# Responses to Comments on Draft Environmental Impact Report

## For the San Francisco Public Utilities Commission's Regional Groundwater Storage and Recovery Project

July 9, 2014

Case No. 2008.1396E

**Figure RTC-1**

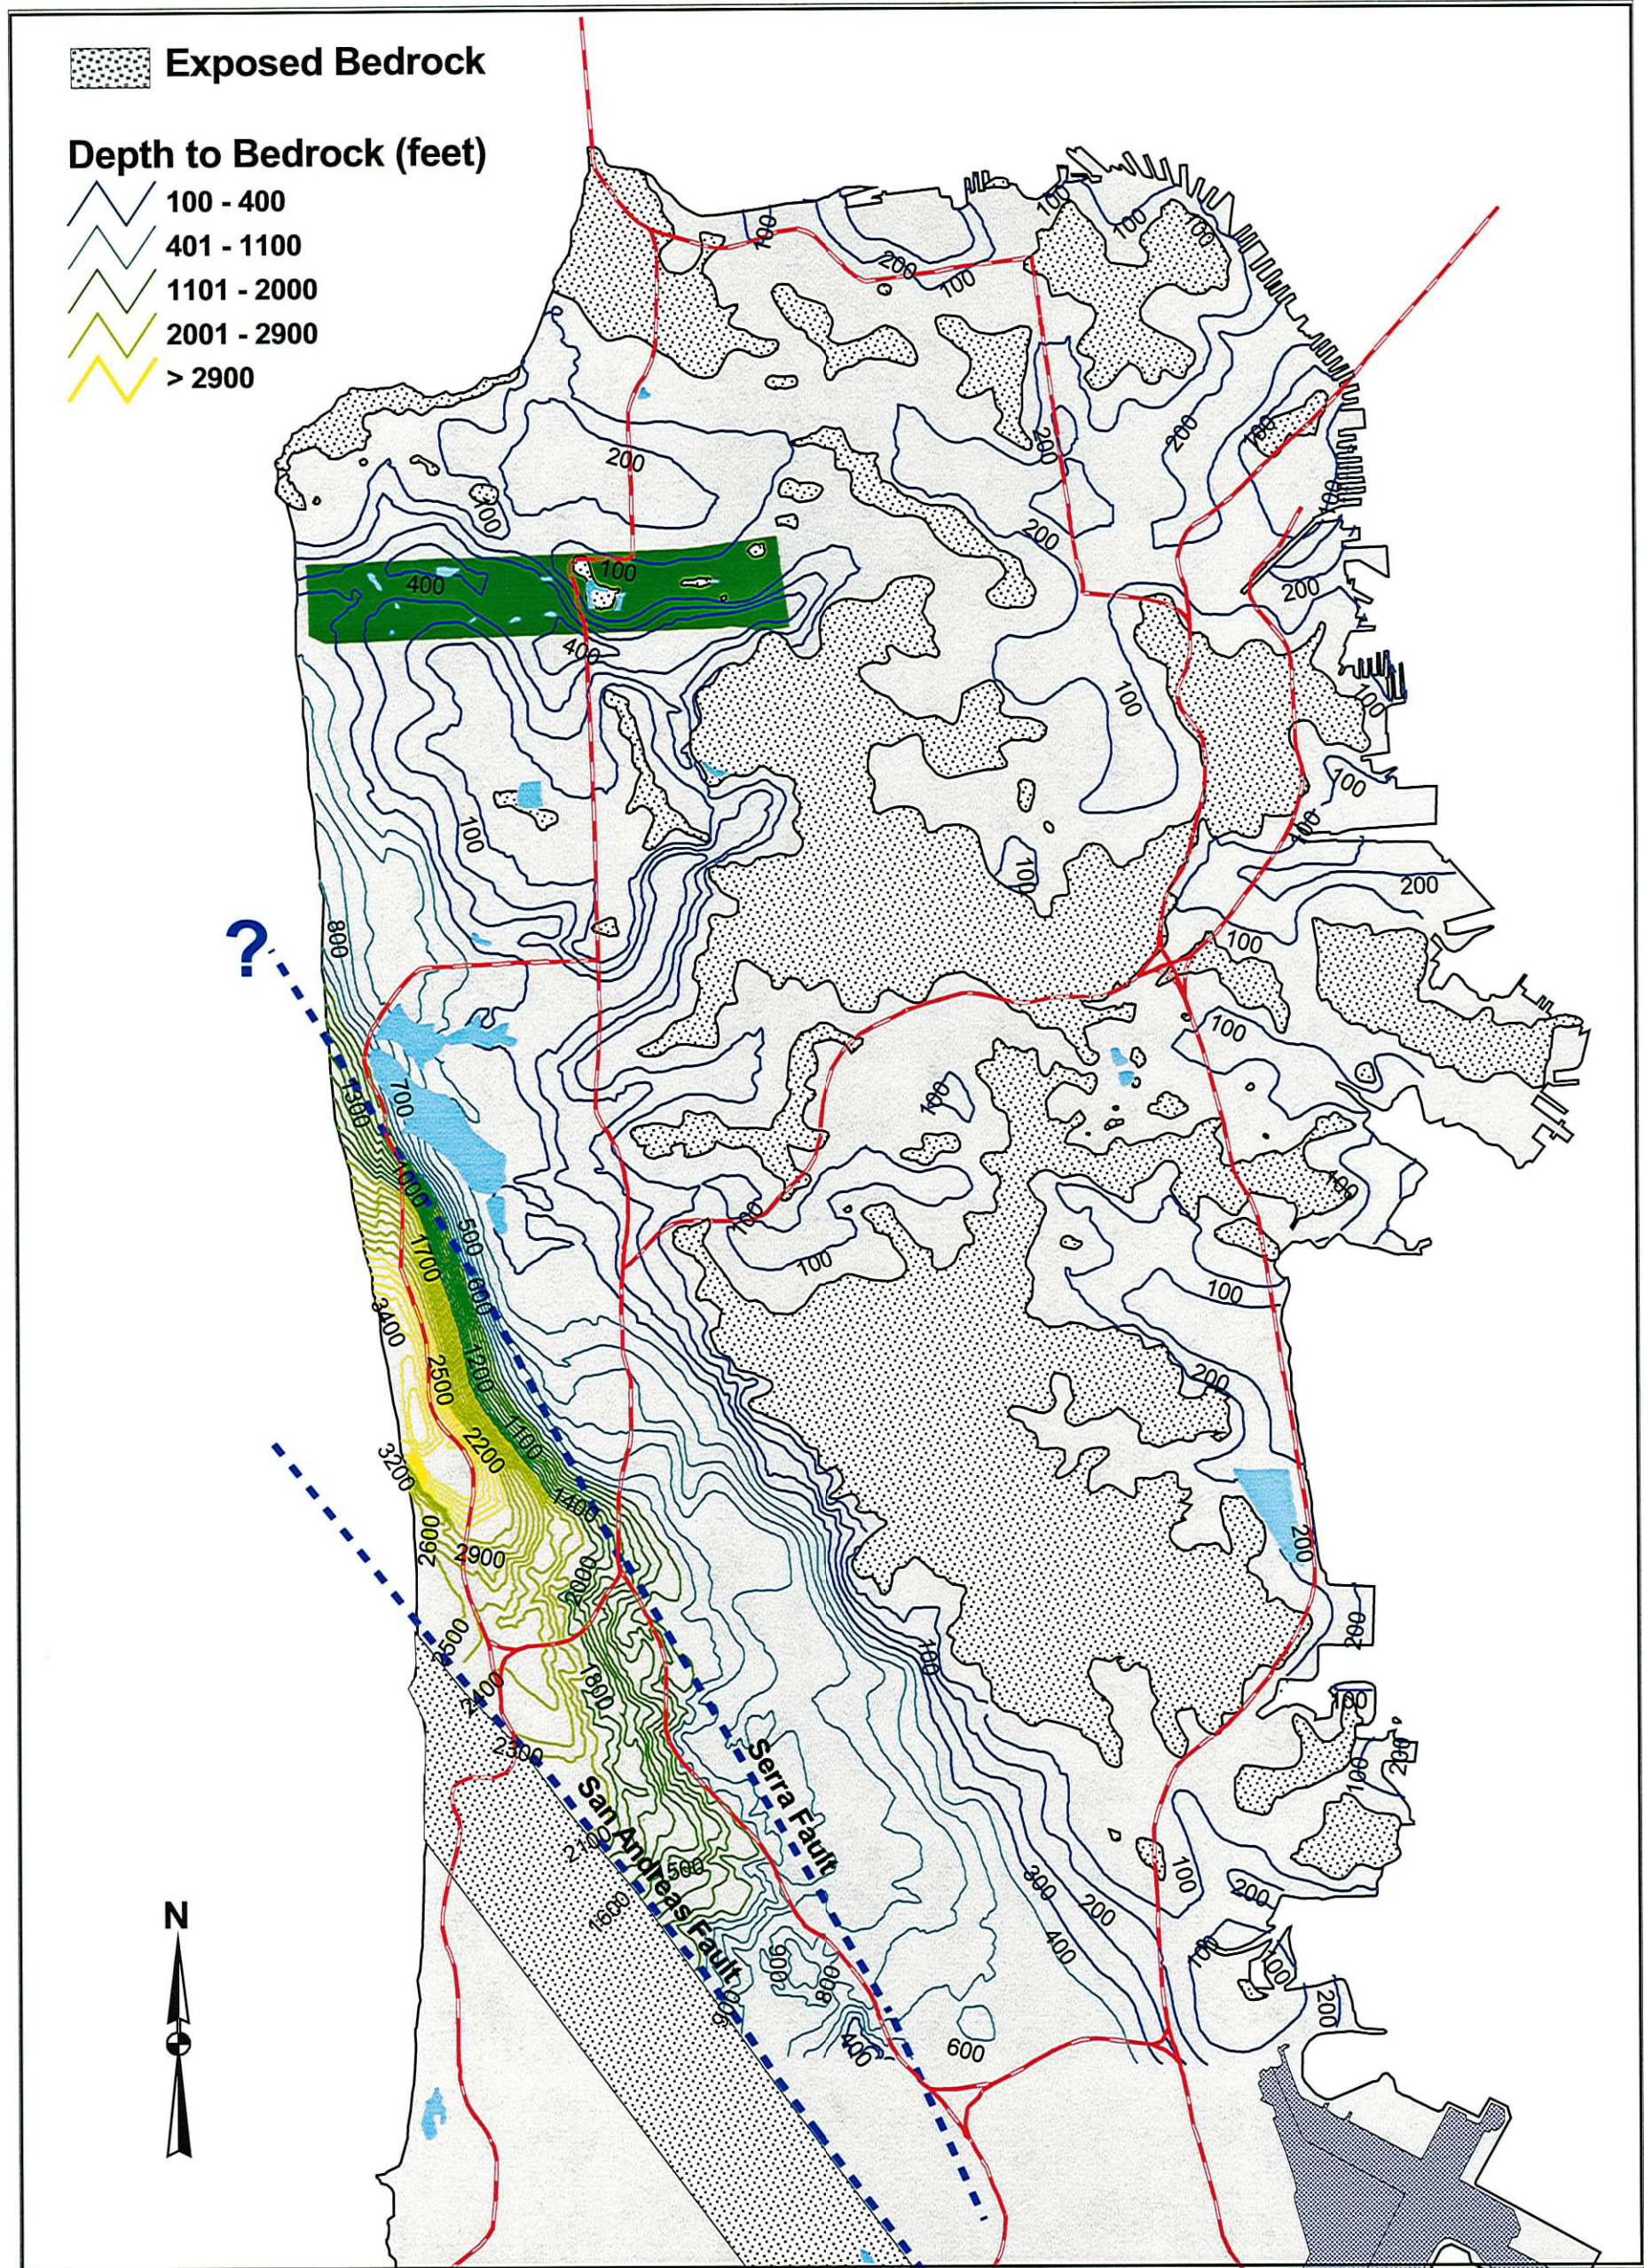
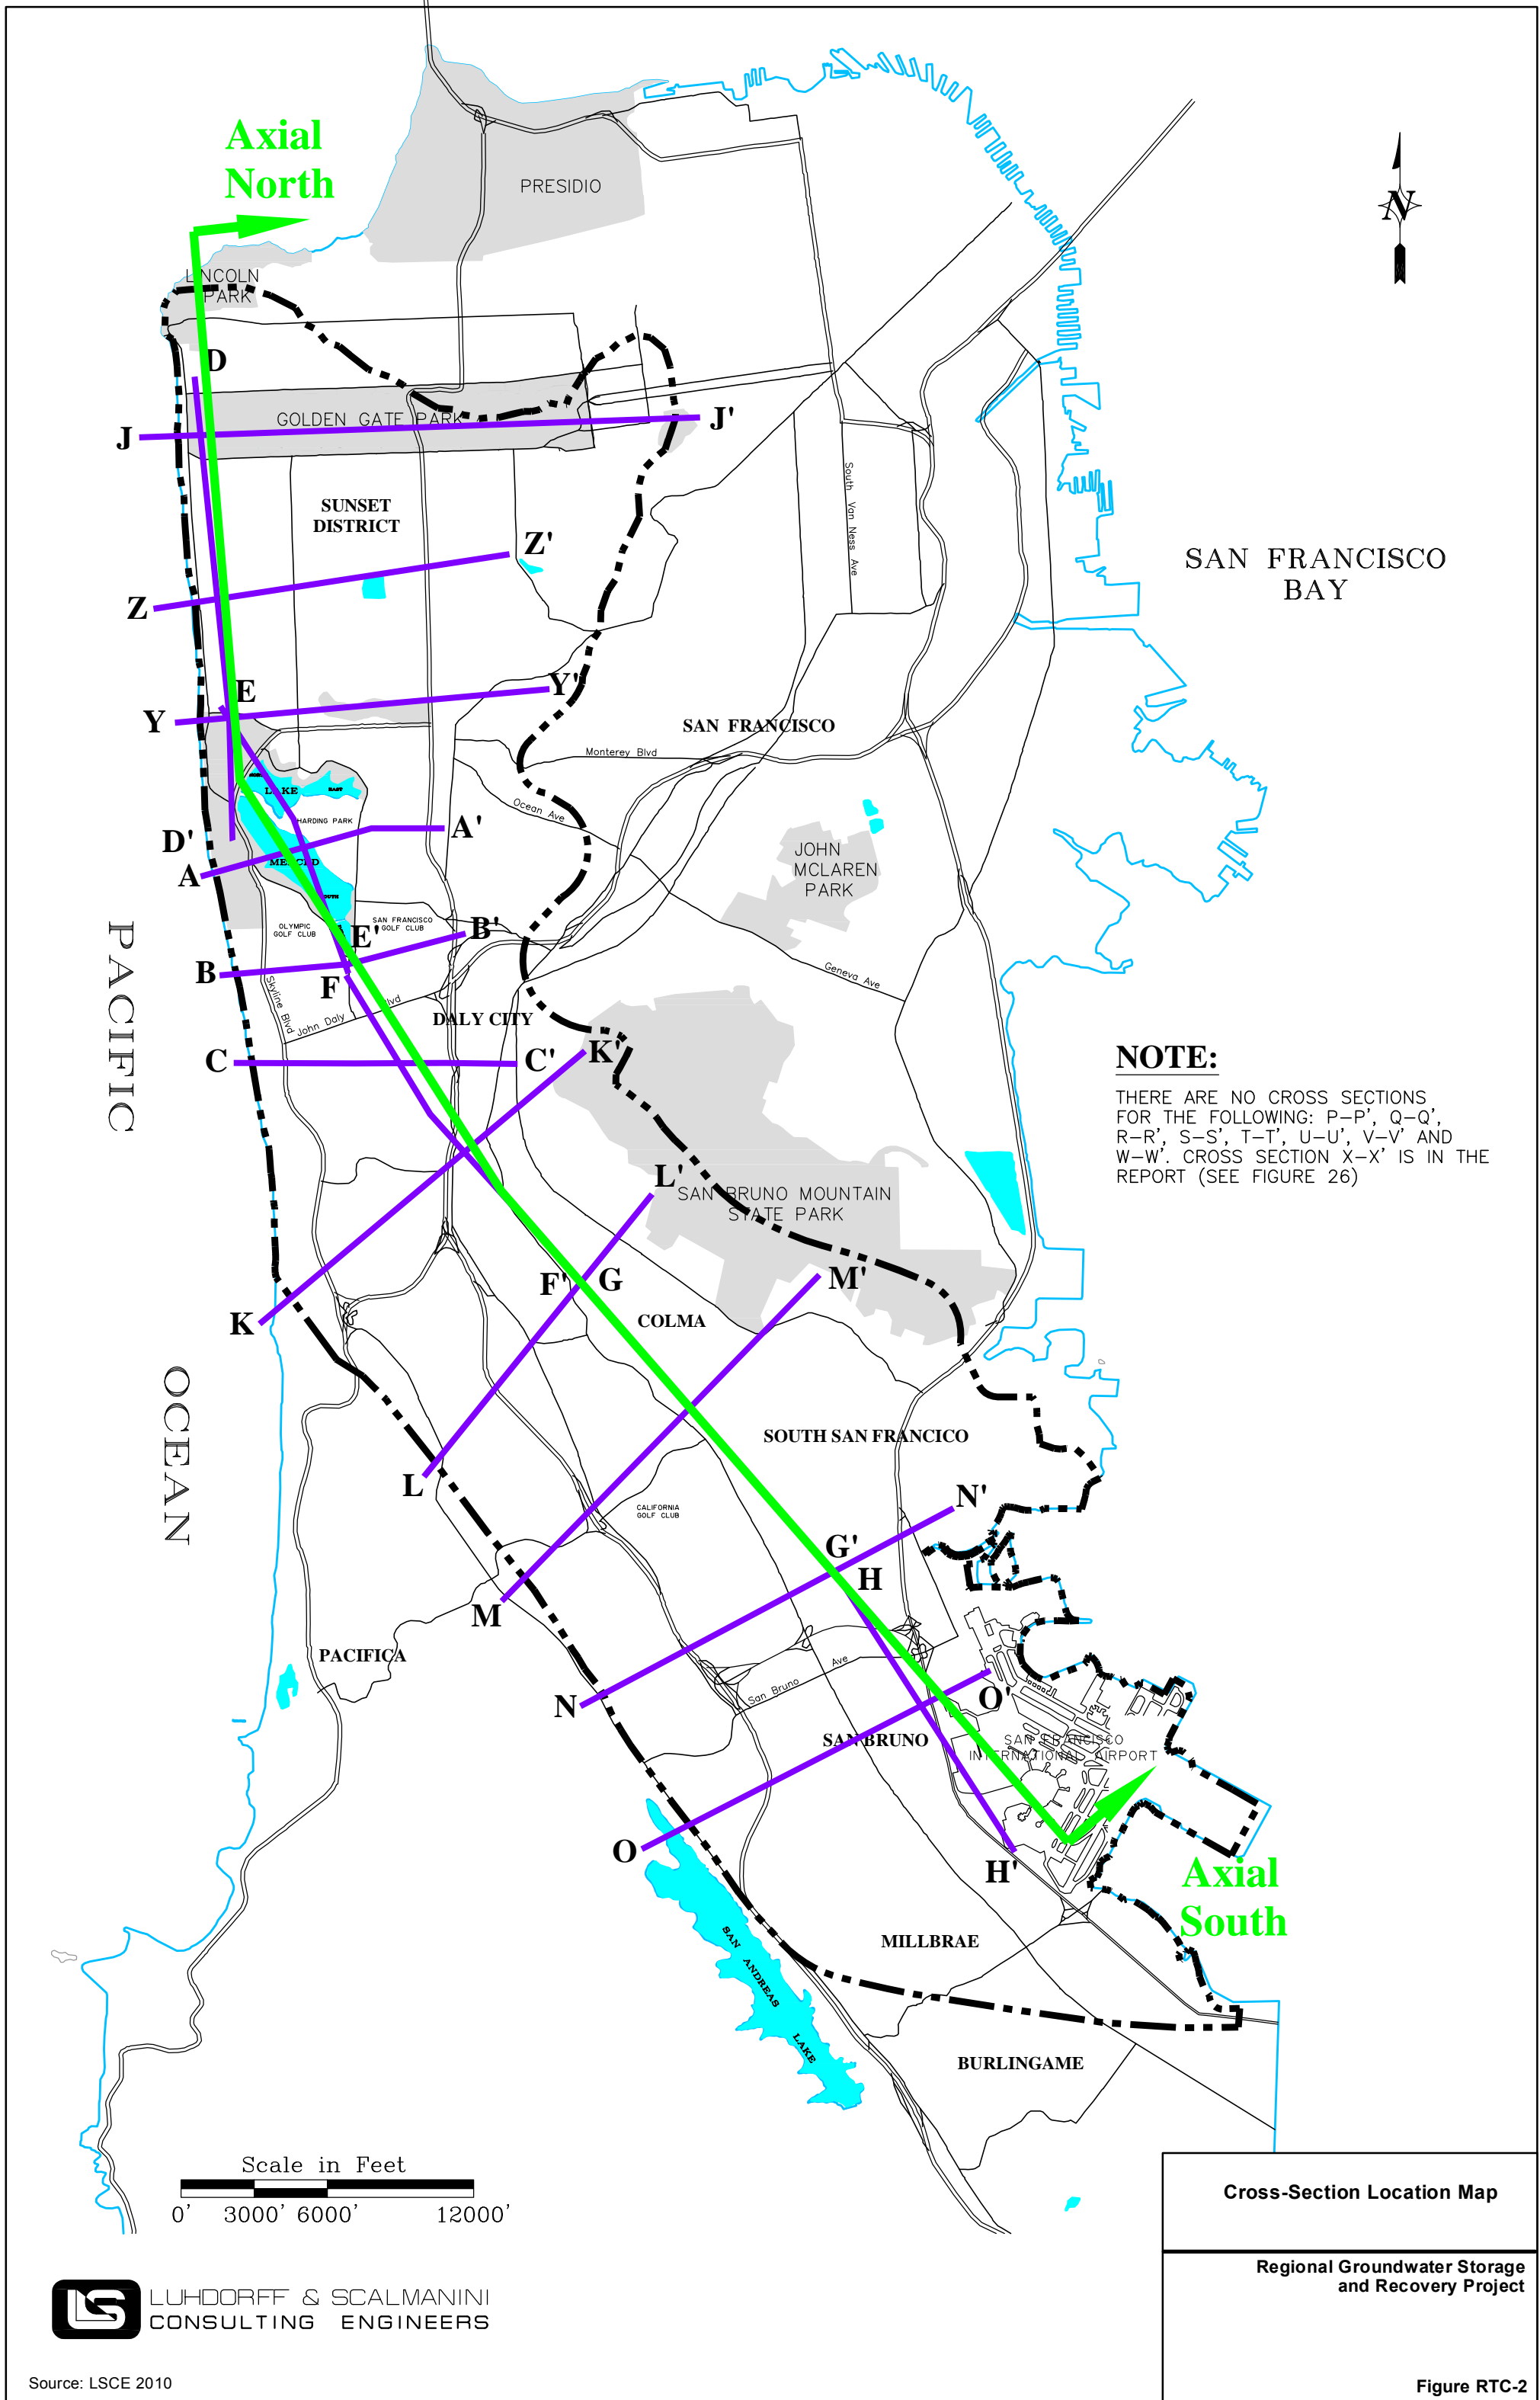
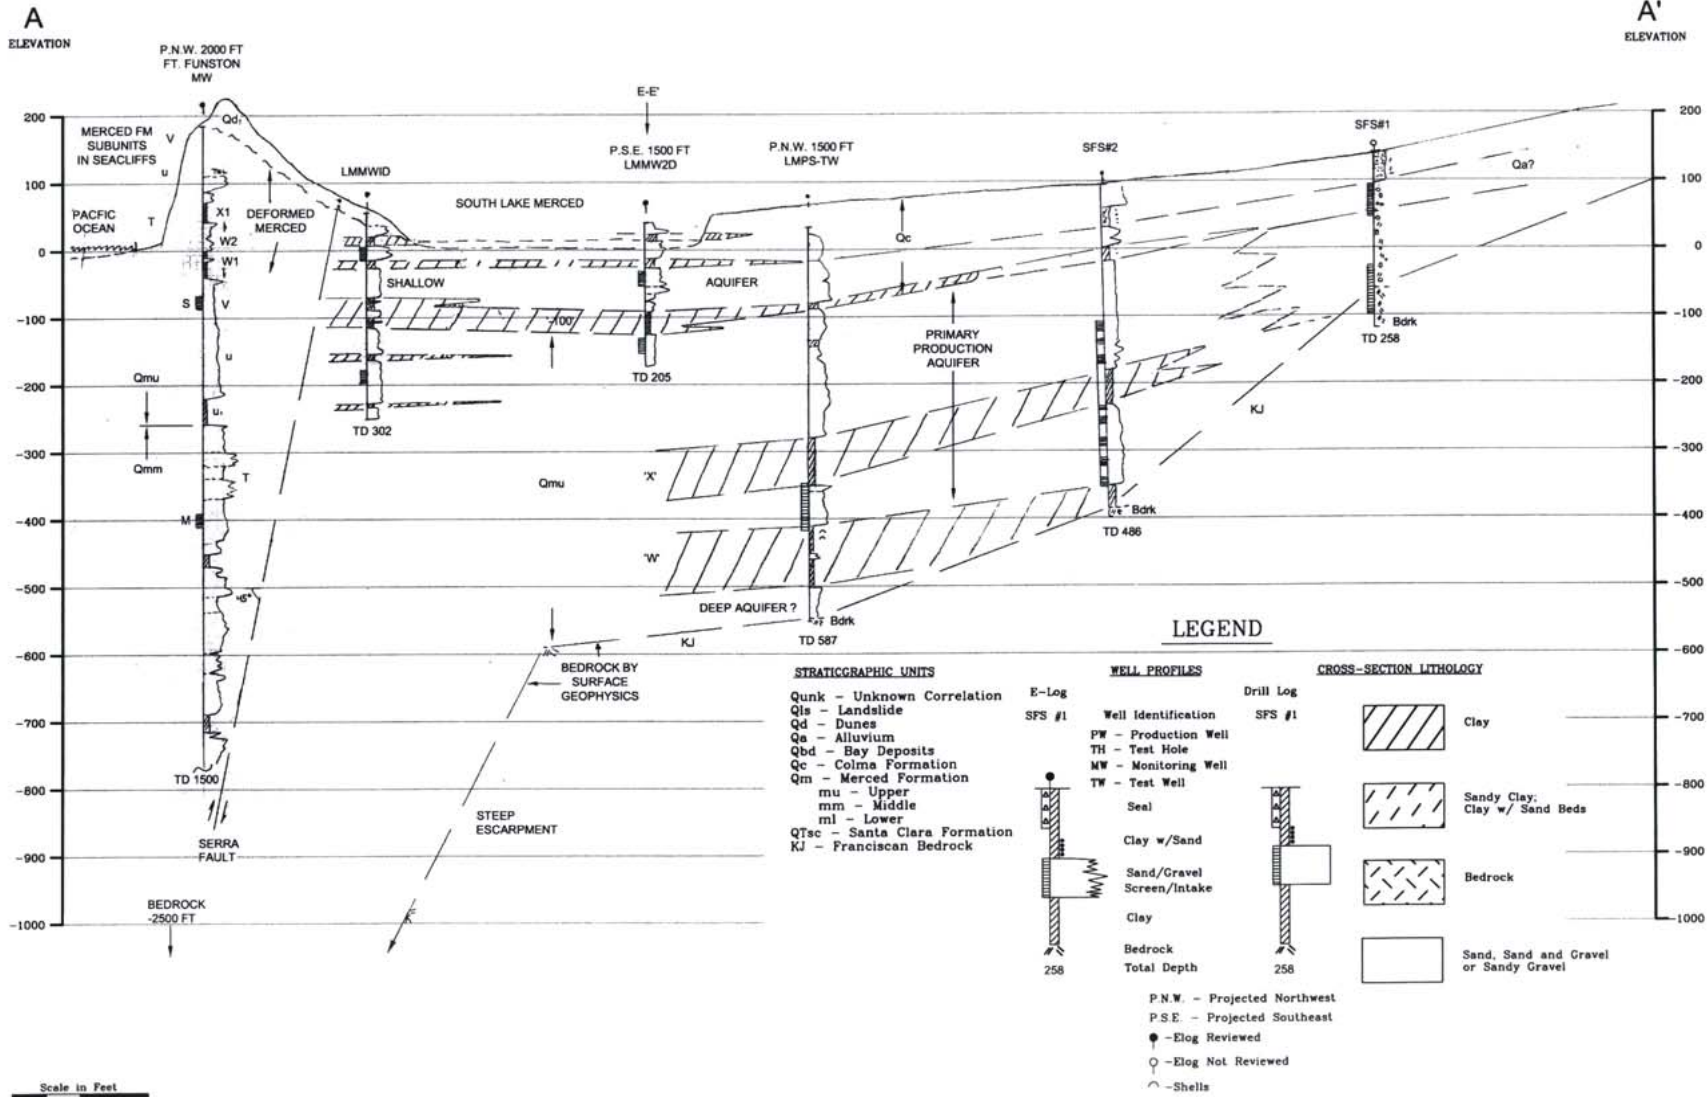
“Item 32 – Why were water levels not included on the cross section?”

The DEIR discusses the water level variability across the Westside Basin and between the various aquifers. It would be very useful to see how measured water levels do in fact vary across the basin and between the aquifers.” (*Cypress Lawn Memorial Park, letter, June 11, 2013 [O-CLMP-Quick]*)

The cross-section, Figure 5.16-2 (North-South Geologic Cross Section, Westside Groundwater Basin), included in the Draft EIR, was selected as being most representative of the characteristics of the groundwater basin that are important to understanding the impact analysis. Additional north-south cross-sections of the basin are included in Appendix H, *Task 10.1 Technical Memorandum, Groundwater Modeling Analysis for the Regional Groundwater Storage and Recovery Project and San Francisco Groundwater Supply Project*, Figure 10.1-3 and the TM's Attachment 10.1-H Figure 7. A reference cited in Draft EIR Section 5.16, Hydrology and Water Quality, *TM 1 Hydrologic Setting of the Westside Basin* (LSCE 2010), provides additional existing setting information relative to seawater intrusion. A figure from the 2010 LSCE report shows the relationship of bedrock to the Serra Fault and other geologic features, and several figures from the report include east-west cross-sections which show the relationship of groundwater basin features in the Westside Groundwater Basin both east and west of the Serra Fault. These figures address the information requested by the comment and are included with this response for reference as Figures RTC-1 (Depth to Bedrock) and RTC-2 through RTC-19 (Cross Section Location Map and cross-sections), respectively.
